List of changes and improvements for the next generation CLIC module

See Module review, lessons learned review CLEX installation, Critical item compendium

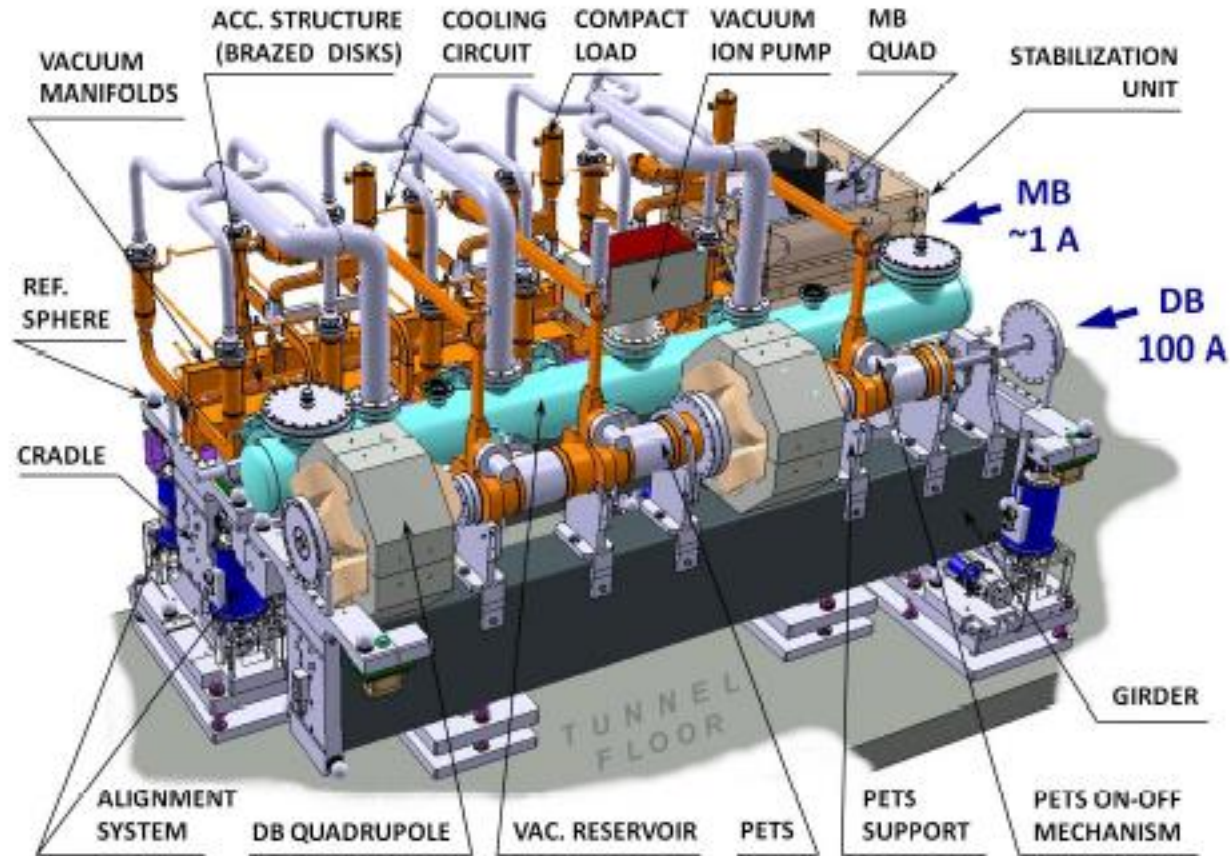
CLIC module in CLEX, clearly needs simplification of waveguide and vacuum system

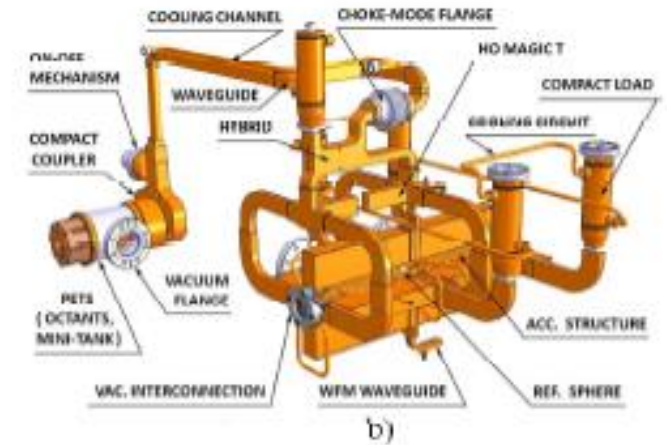
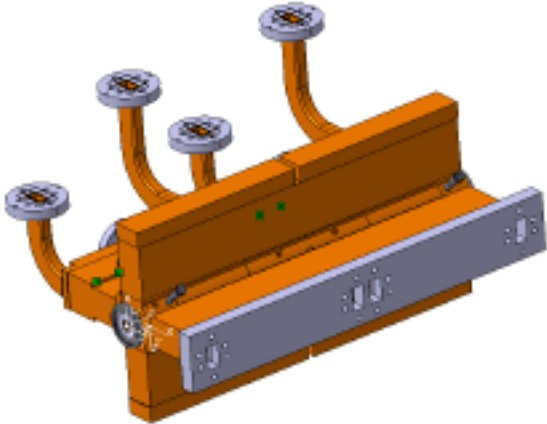
What is actually presently our rf unit ?

2x this!!

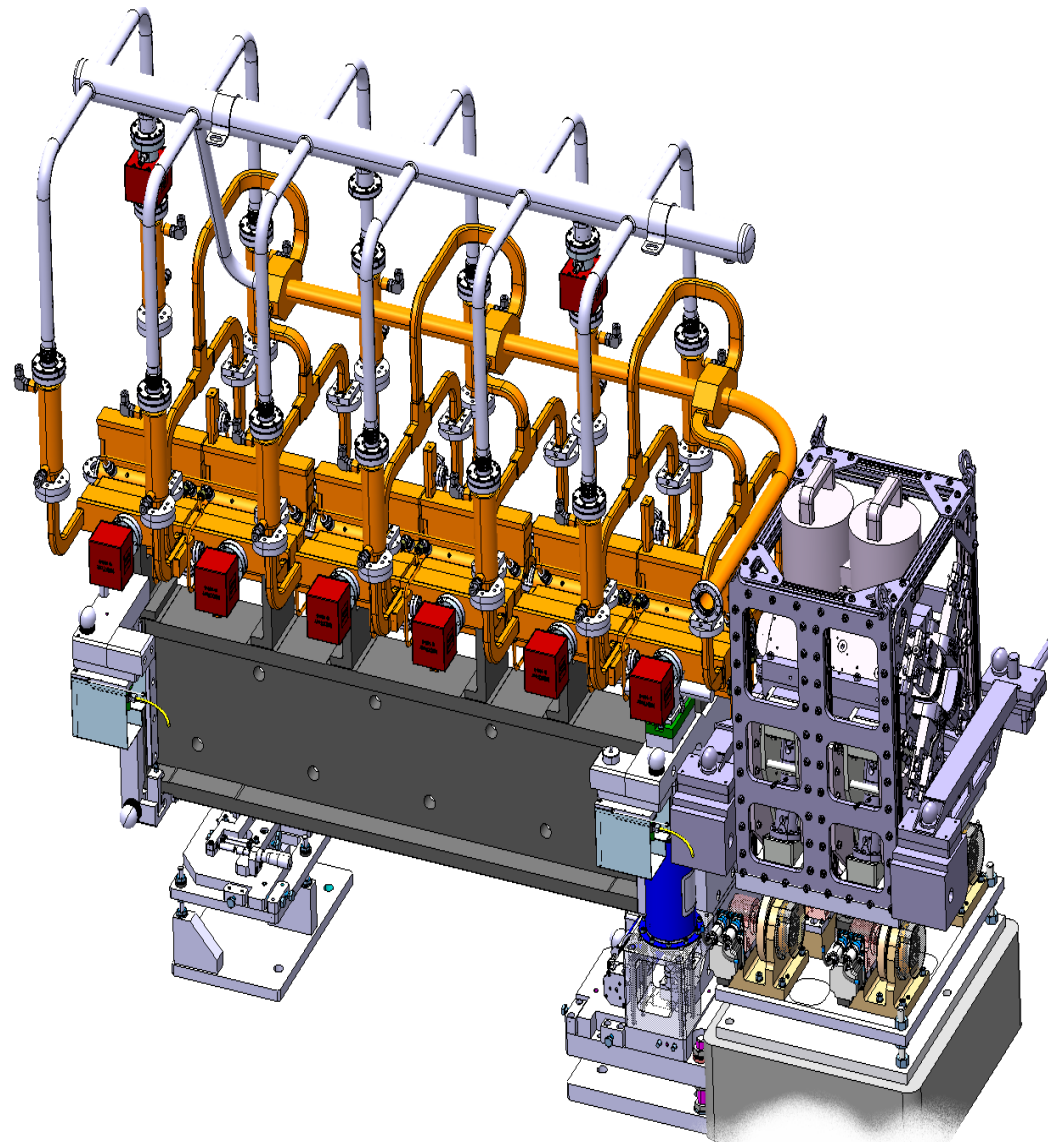
More detailed analysis is needed, large potential for improvements

Independent DB quad supports

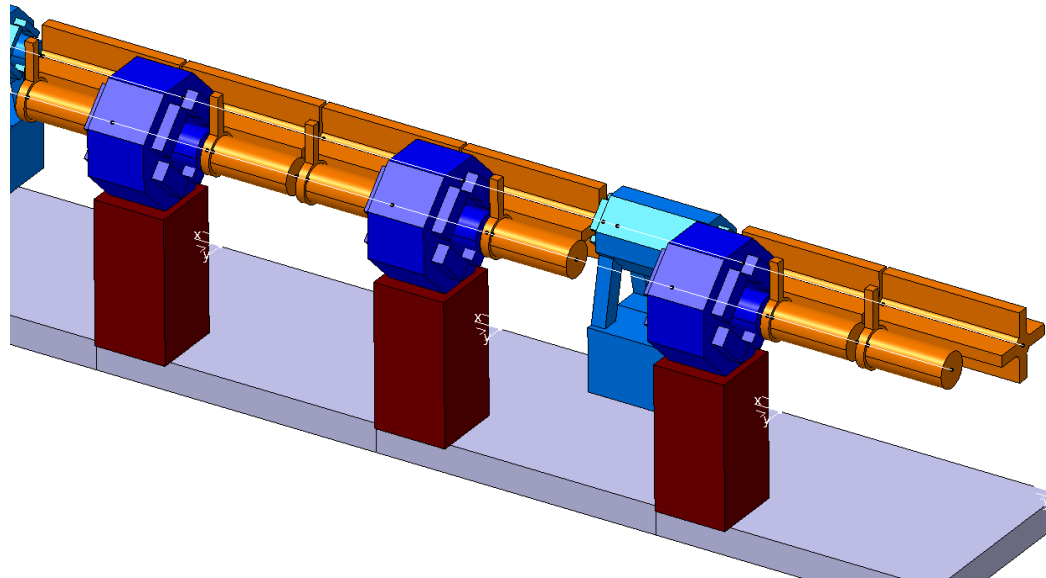
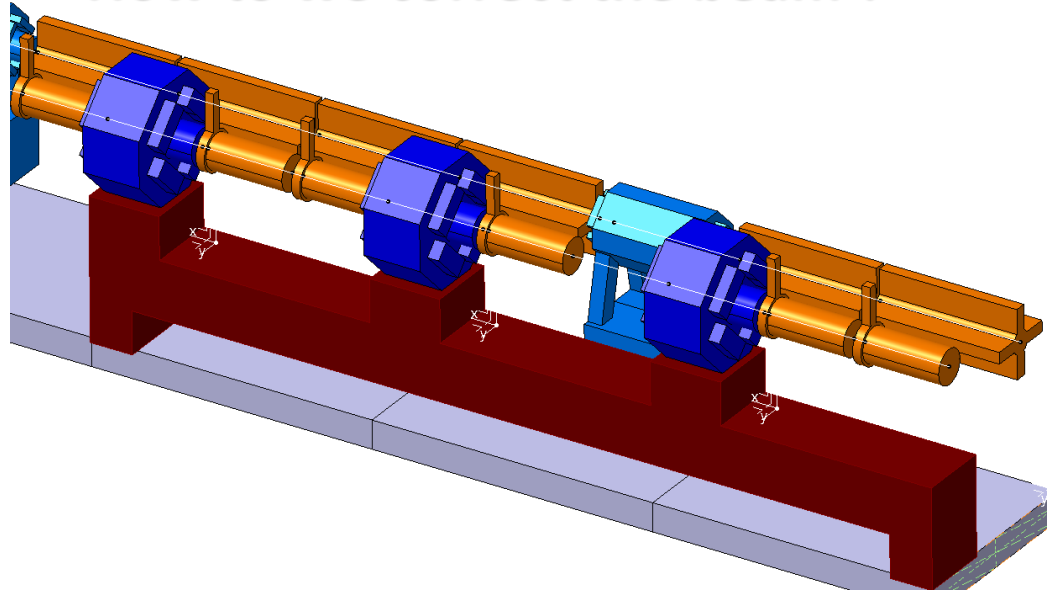
How to we correct the beam ?
